**TECHNICAL EVALUATION REPORT
CHRISTENSEN RANCH MINE UNITS 2 THROUGH 6 RESTORATION REPORT
URANIUM ONE USA, INC., WILLOW CREEK ISR FACILITY**

DATE: October 23, 2012

DOCKET NO.: 040-08502

LICENSEE: Uranium One USA, Inc.

Figure 3c. MU2 North and South Radium-226 Stability Monitoring Trend Analysis

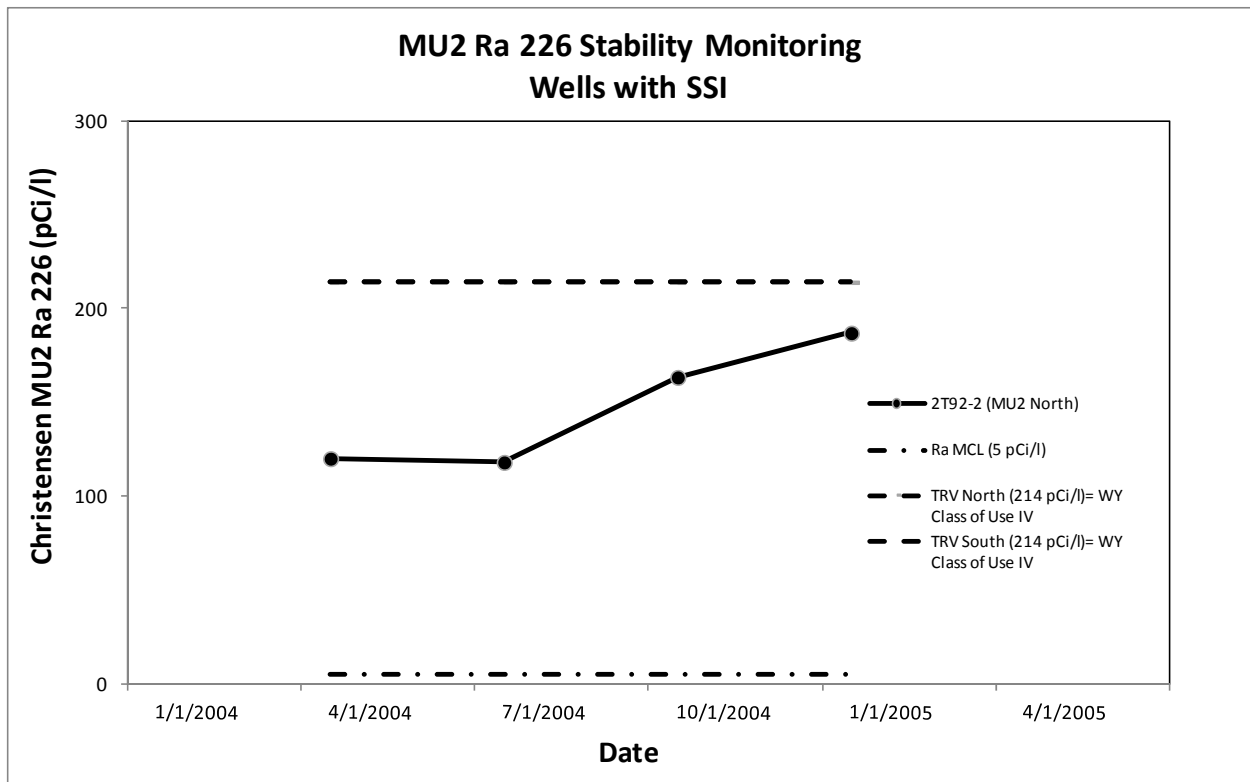
The SSI trend for Mine Unit 2 South for uranium in this well is shown in Figure 3c. It is of concern to the staff because it shows that uranium in this well is above the Class IV standard (background TRV) and is increasing.

- (1) Demonstrate that the SSI trends for uranium and radium-226 at well 2T92-2 are reversed and stable.
- (2) Provide a confirmatory analysis of the groundwater quality at well 2MW108 subsequent to the corrective actions for the 2011 excursion that demonstrates impacts to the aquifer following the 2011 excursion event meet regulatory requirements (groundwater protection criteria).
